## 63xx Fisheye Camera Firmware

Version: V5.4.14 build160427

### Release Note

**(2016-05-16 External)**

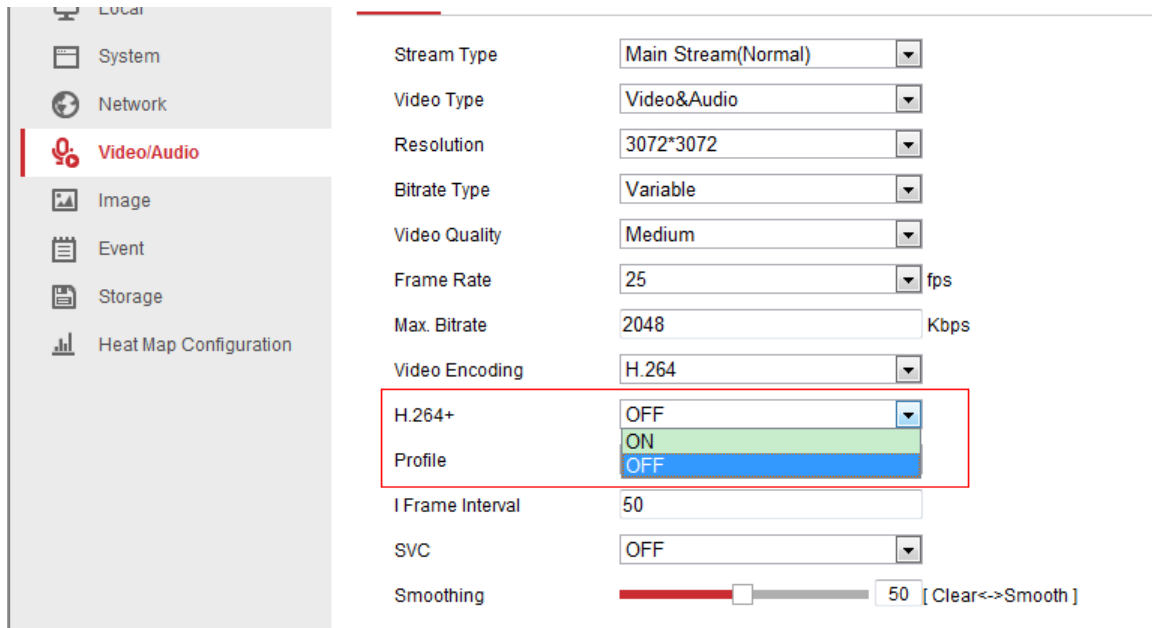
- Black the area which is out of the fisheye view and make it more obvious between the internal and external parts.

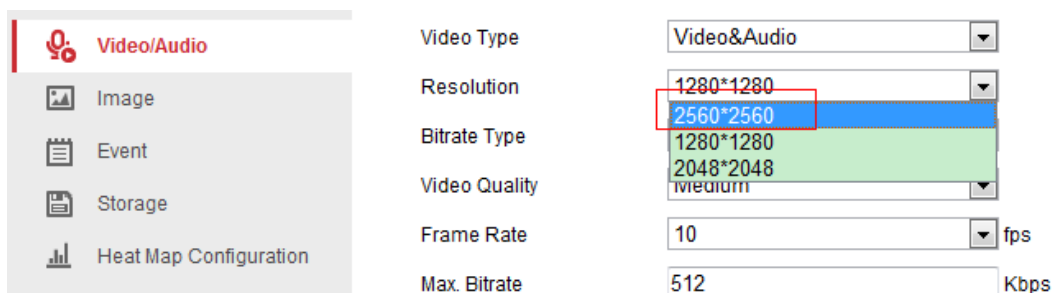
- In the 4PTZ mode, the resolution of DS-2CD6332 is increased from 800\*600 to 1280\*960@25/24fps and DS-2CD6362 is increased from 1024\*768 to 1600\*1200@15/12.5fps.
- The fisheye channel of DS-2CD6362 newly adds the 2048\*2048 resolution in the fisheye+panorama+3PTZ mode. The maximum frame rates of each channel are modified to 12.5fps, 12fps, 8fps, 8fps, 8fps.
- For DS-2CD63C2, the default resolution of fisheye channel is modified from 1280\*1280 to 2560\*2560 in the fisheye+3PTZ mode.
